*City of Bristol
Planning Commission*

**REGULAR MEETING - MONDAY, SEPTEMBER 22, 2025
CITY HALL COUNCIL CHAMBERS
111 NORTH MAIN STREET
6:00 P.M.**

CITY OF BRISTOL
SITE PLAN REVIEW COMMITTEE
STAFF COMMENTS - #440

SITE PLAN: "Crown Estates" Site Plan for a multi-family residential development (30 units) at Wolcott Street & Old Wolcott Road; Charlie Talmadge, Applicant. Plans Dated: August 11, 2025 (latest revision); Date of Committee Review: September 3, 2025 (first review)

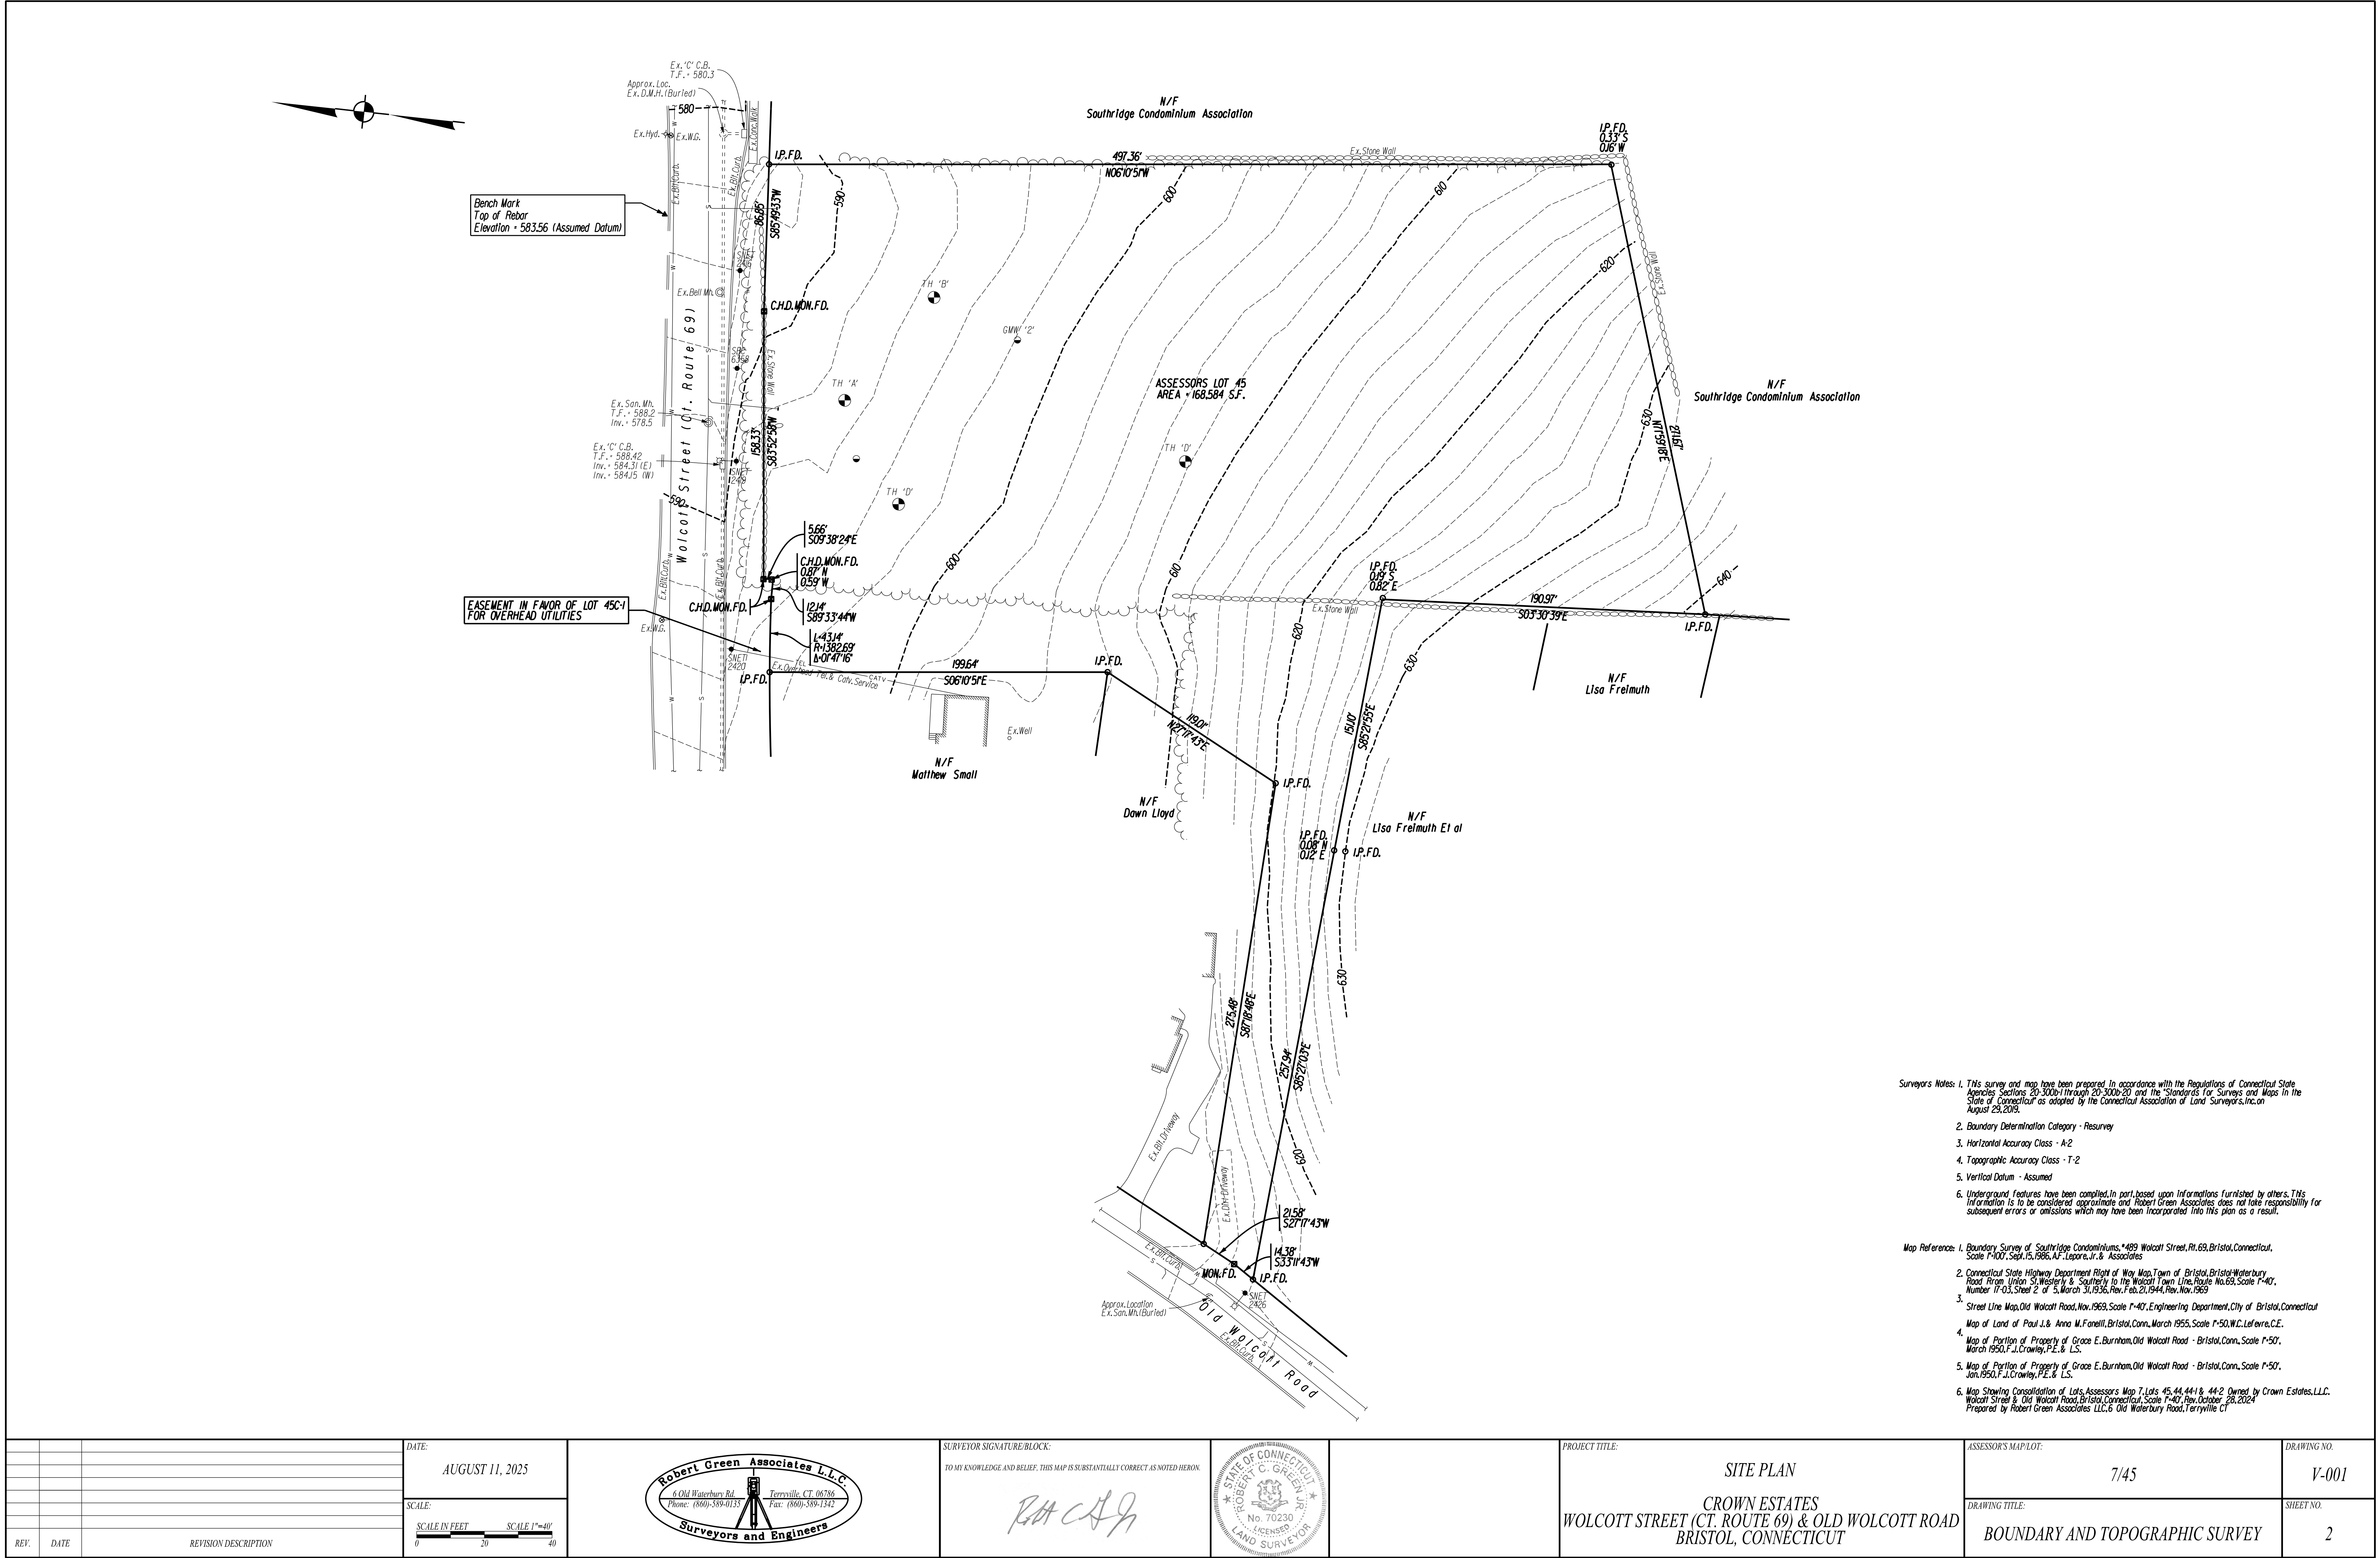
2. Verify on sheet 2 that the northerly property corner on the Old Wolcott Road stub is Found.
3. There are several notes that need to be updated, along with the zoning table on sheet 3.

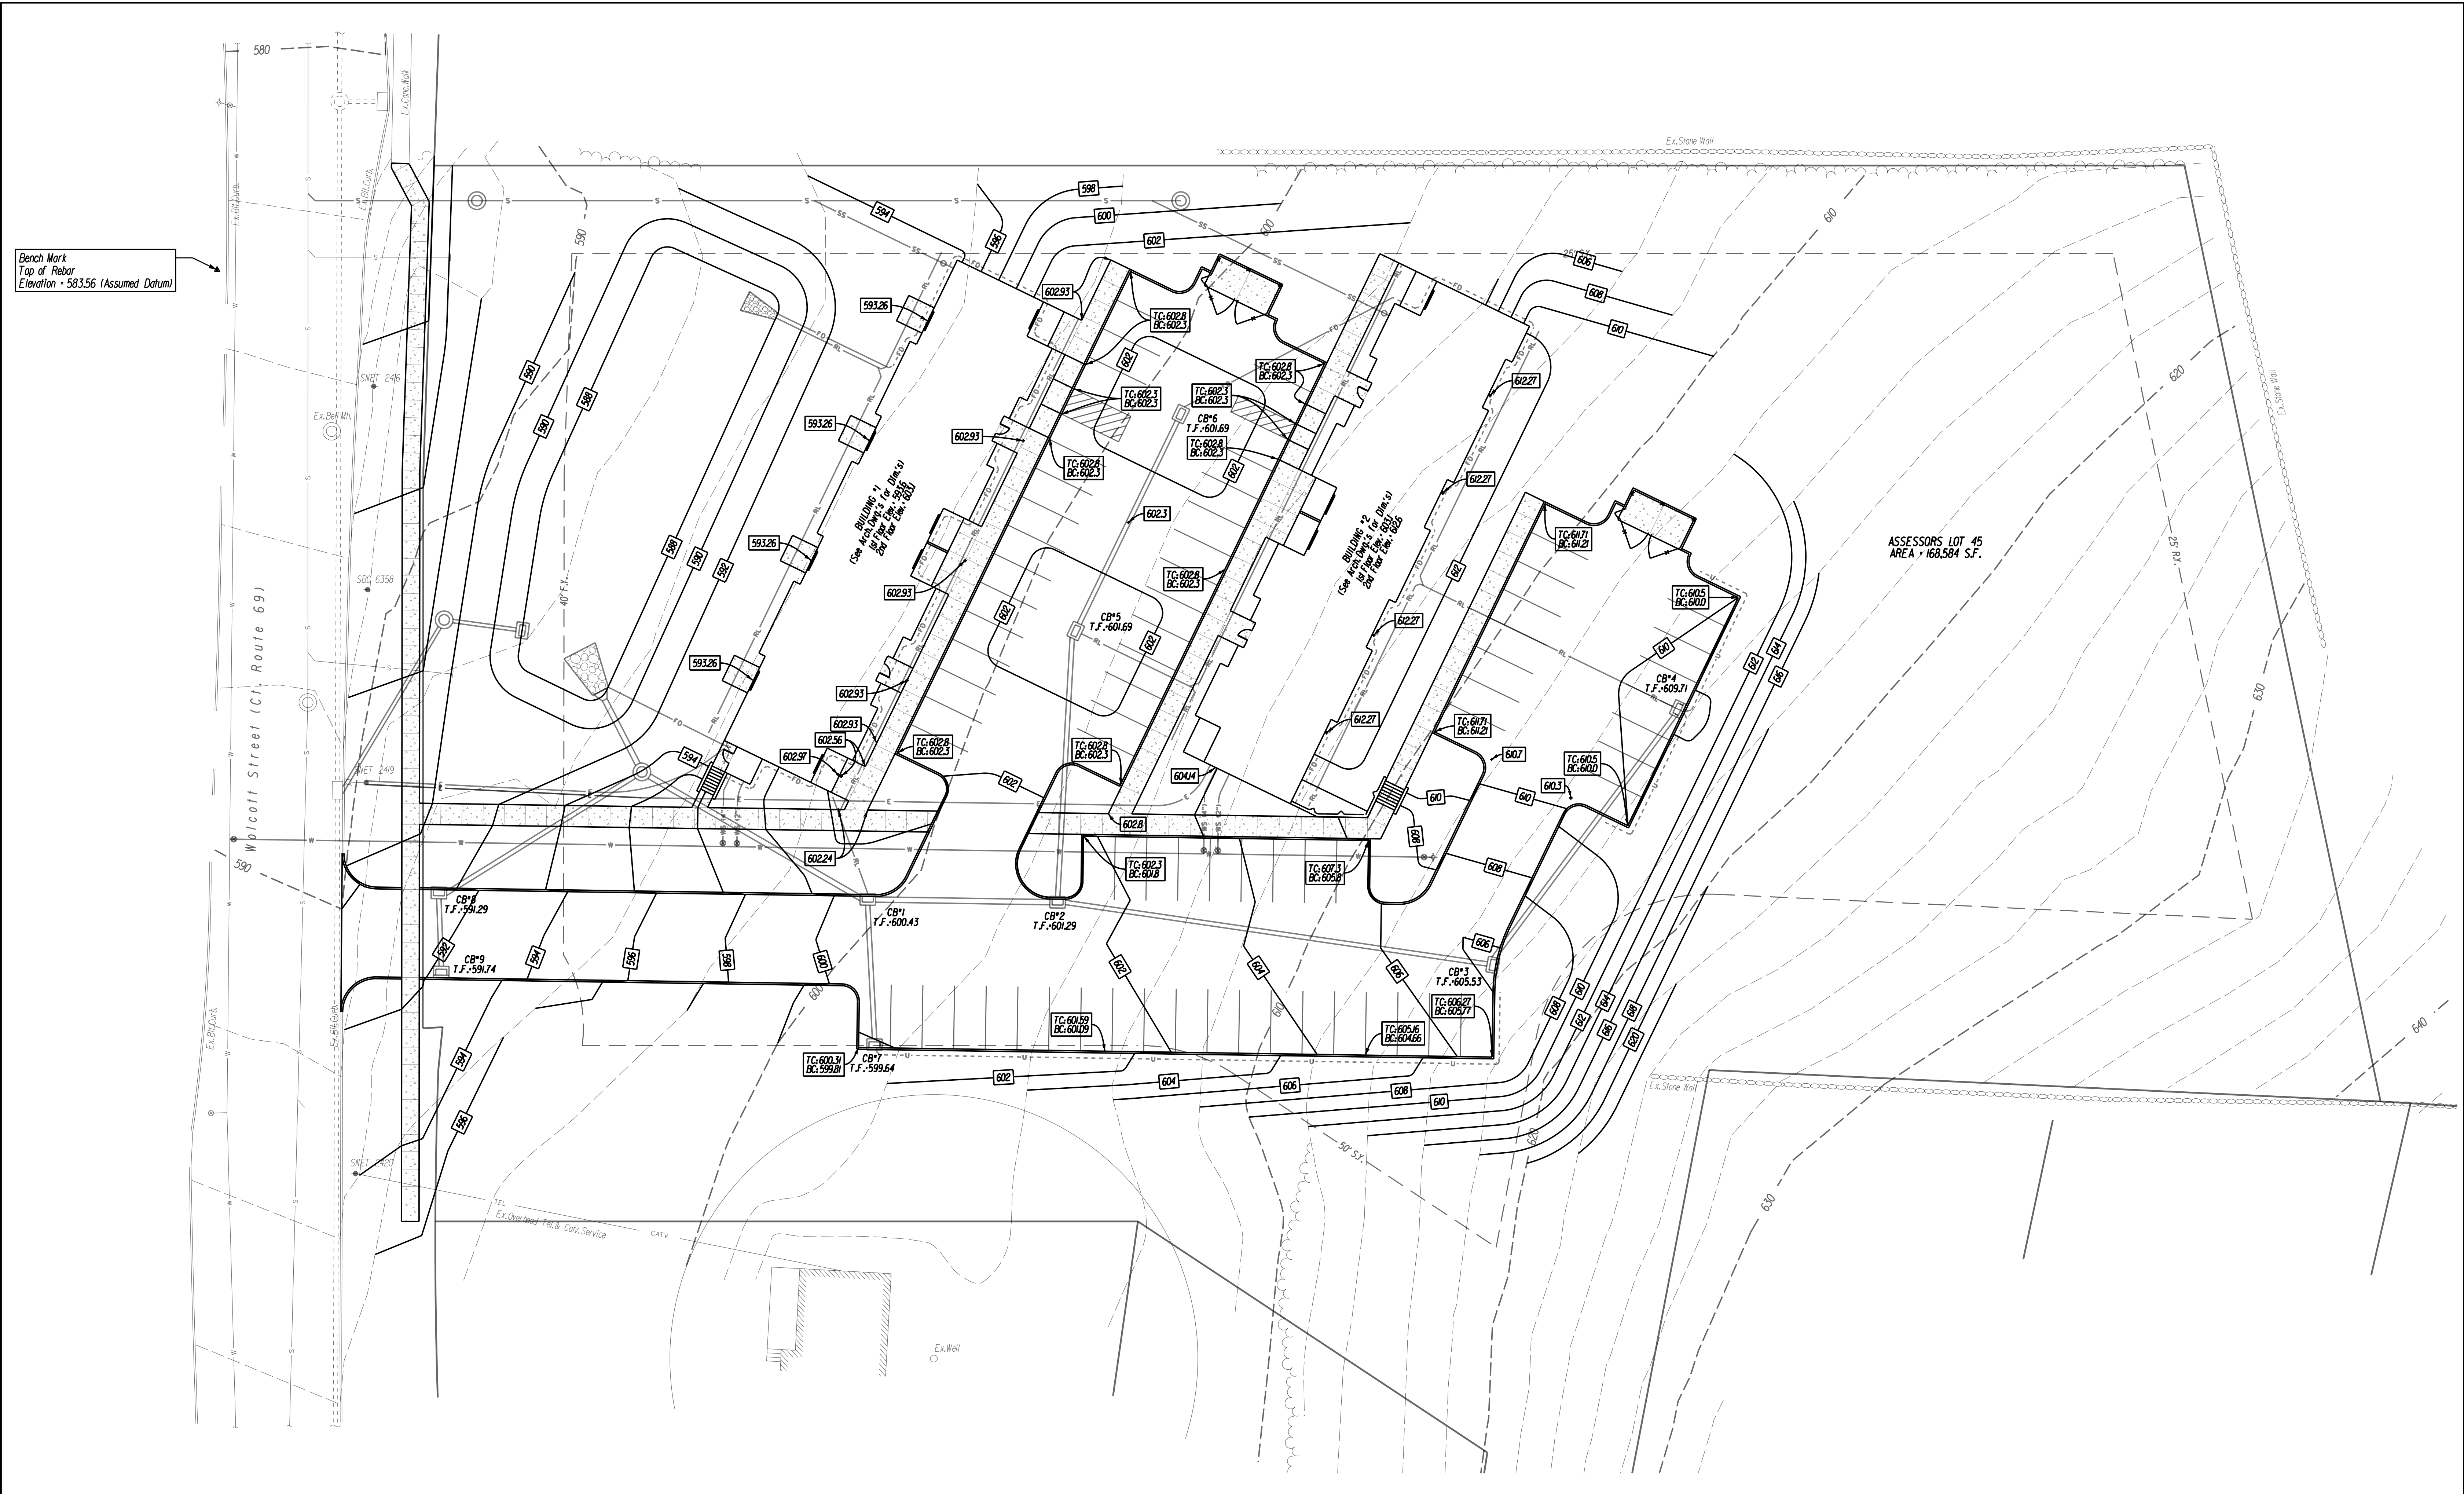
6. On page 6 the discharge from the storm drainage basin onto Wolcott Street appears to go through SNET pole 2419.
7. The grading shows the sidewalks being constructed on Wolcott Street are at around 5%, a note should be placed on sidewalk that the maximum grade is 5%. Also add the sidewalk width. Is the walk 6 feet wide like the rest of the site?

DRAWING TITLE:
LANDSCAPE PLAN

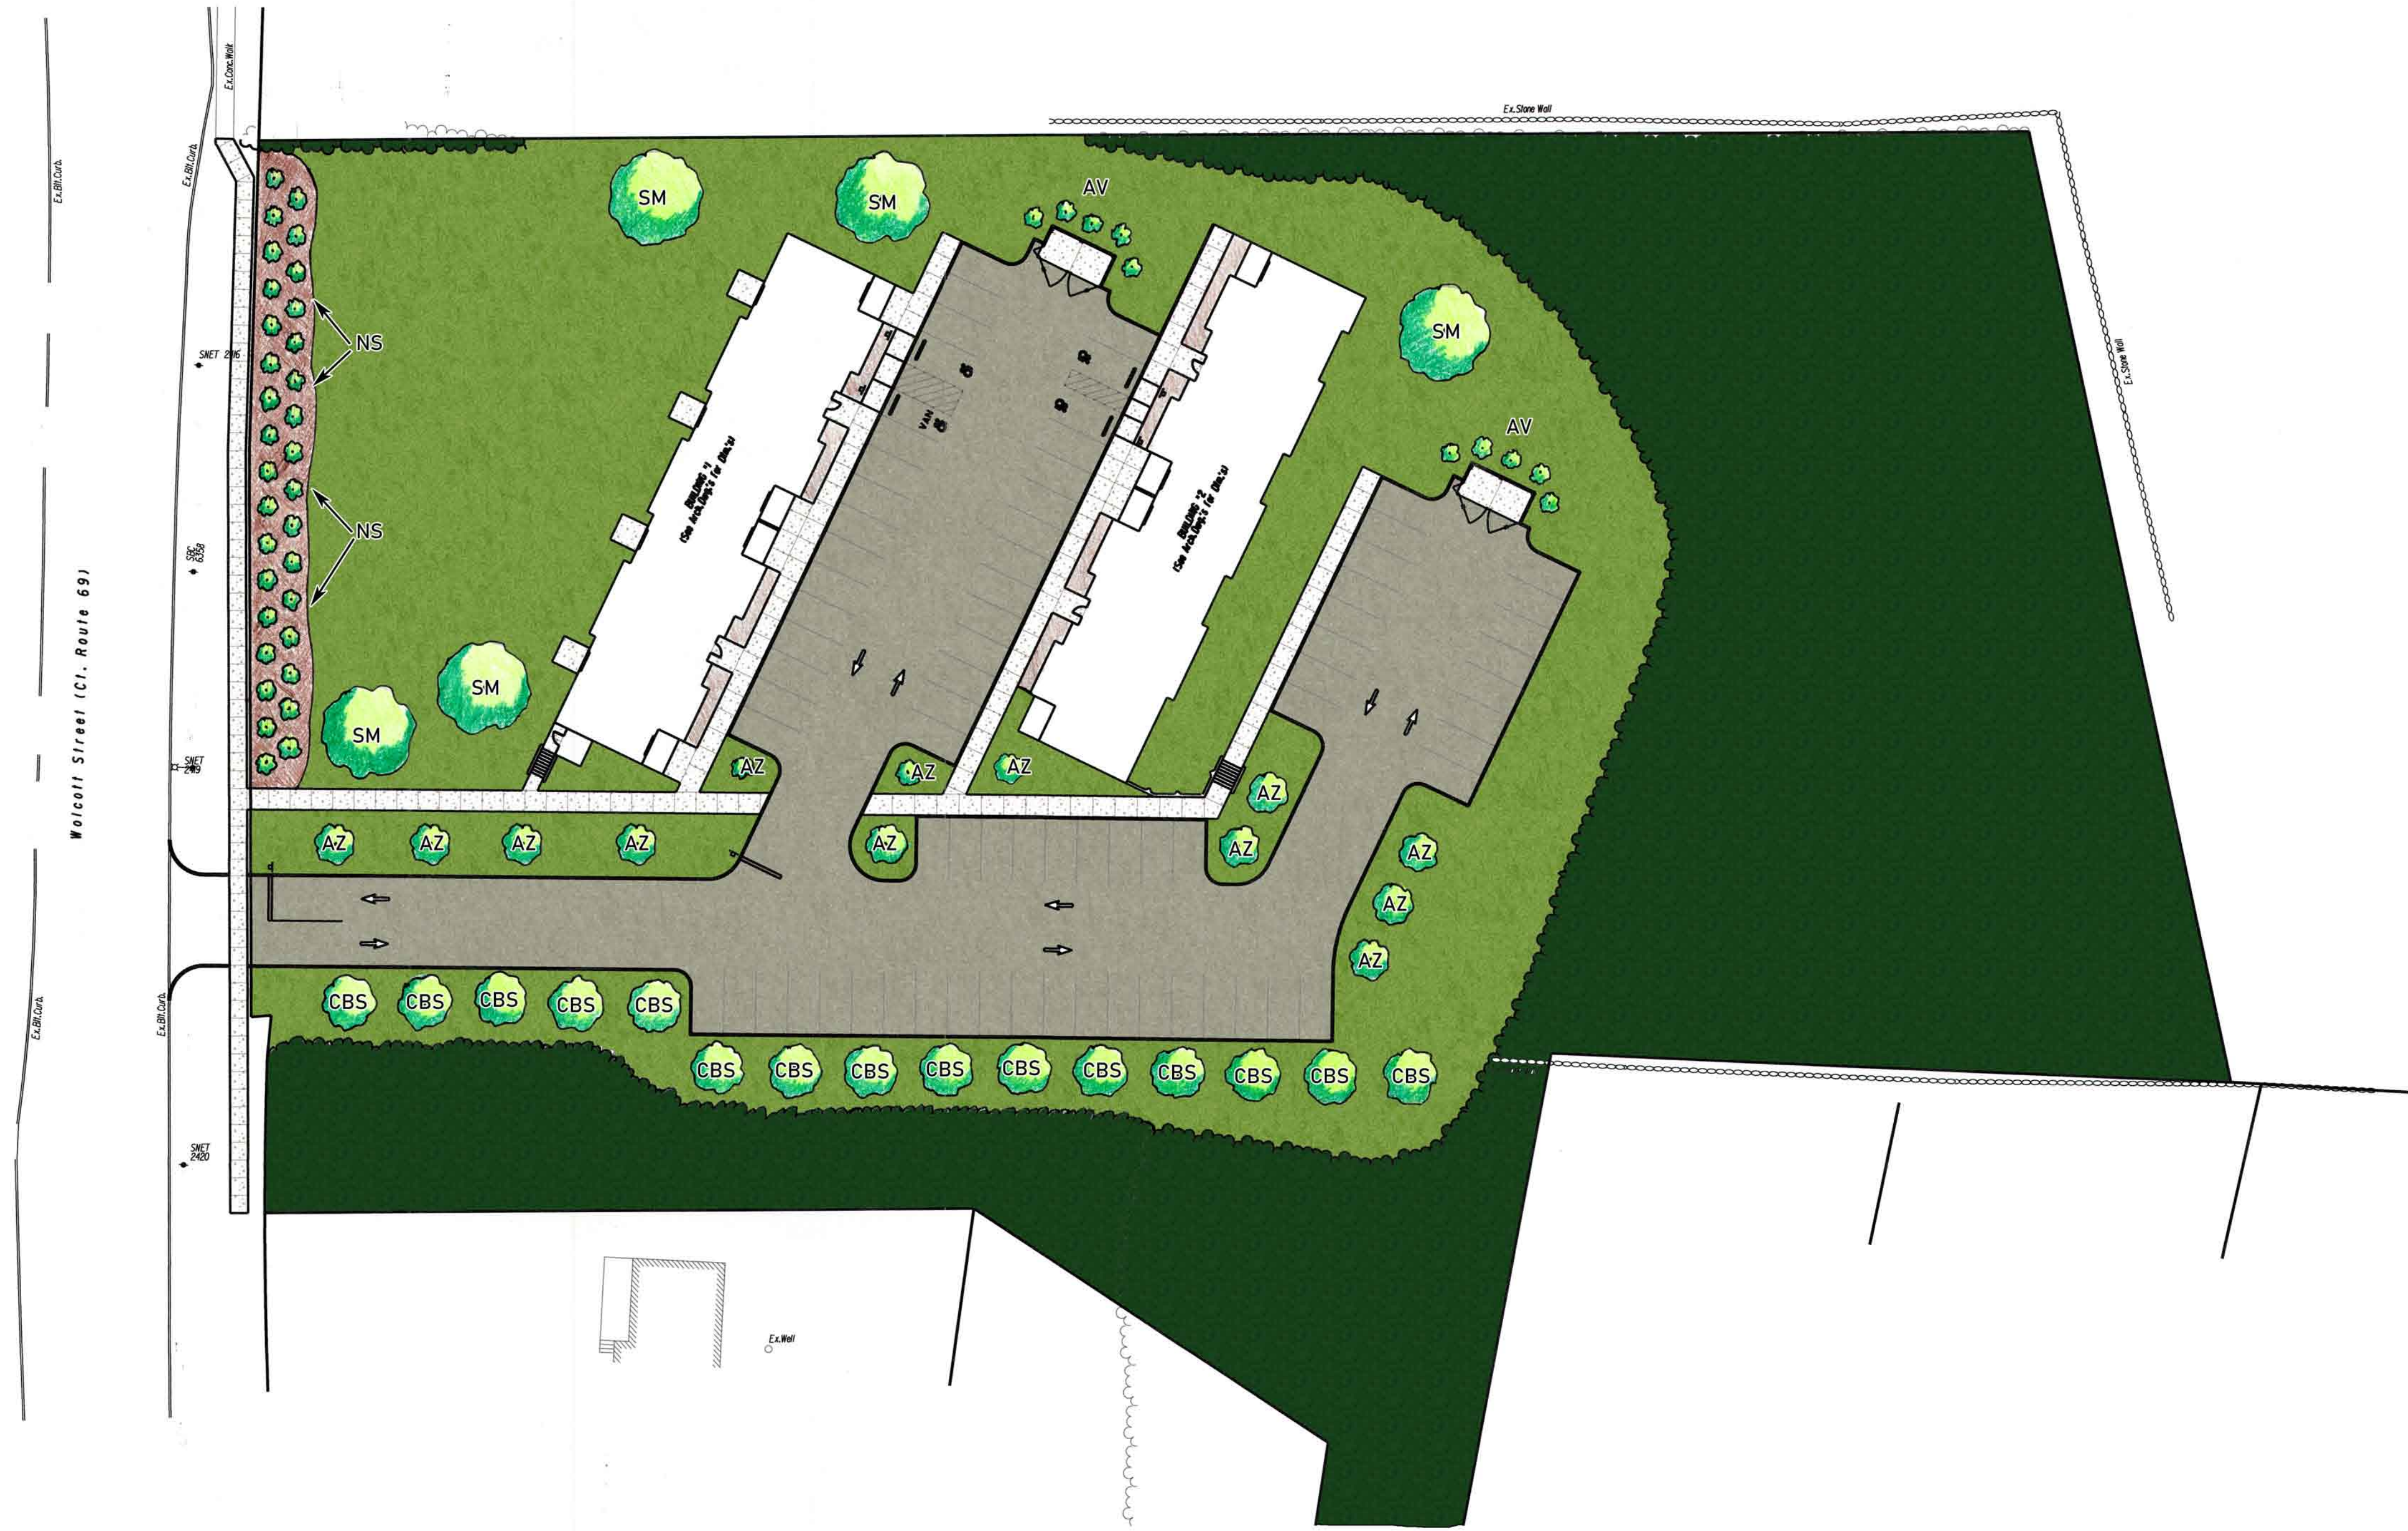
5. Landscape plan incorrectly shows existing vegetation in green to the South. Aerial mapping and survey shows this area is not vegetation as shown. Revise landscape plan to portray existing conditions. Staff suggests

12. The narrative and plan notes say the property consists of 3.87 and 3.89 acres. Correct and revise.
13. Remove “quantities” from Landscape plan note #5. Final quantity of landscape materials will not be varied or will be determined by staff.
